Environmental  
Protection Agency

July 11, 2011

RE: SUMMIT COUNTY  
CITY OF MACEDONIA  
WESTERN RESERVE  
GRACE BRETHERN CHURCH  
CONSTRUCTION STORM WATER

Figure 1 – The current outlet structure is not appropriate for treating sediment-laden water.

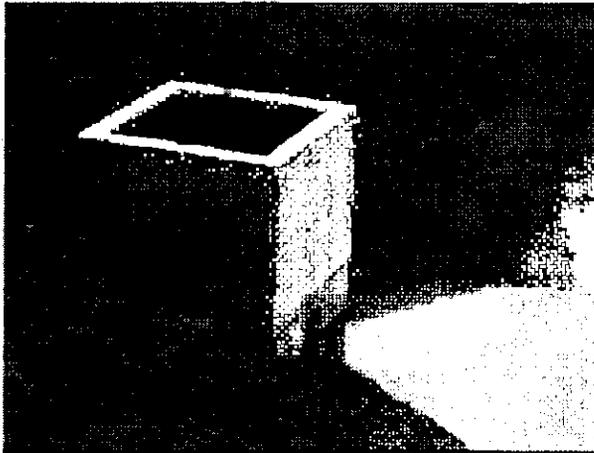
1. The sediment basin/trap that is present on site does not have an appropriate outlet structure (Figures 1 and 2). Although the Storm Water Pollution Prevention Plan (SWP3) calls for a sediment trap, a sediment basin is really necessary to treat the runoff from a site of this size. You should contact the engineer for this project to request the design specifications of a properly designed outlet structure (either a riser pipe or a skimmer device). The design requirements for these structures can be found in the *Rainwater and Land Development Manual* (Ohio Department of Natural Resources, 2006), available on-line at <http://www.dnr.state.oh.us/tabid/9186/default.aspx>.

Figure 2 – A riser pipe or skimmer device is needed on the sediment basin.
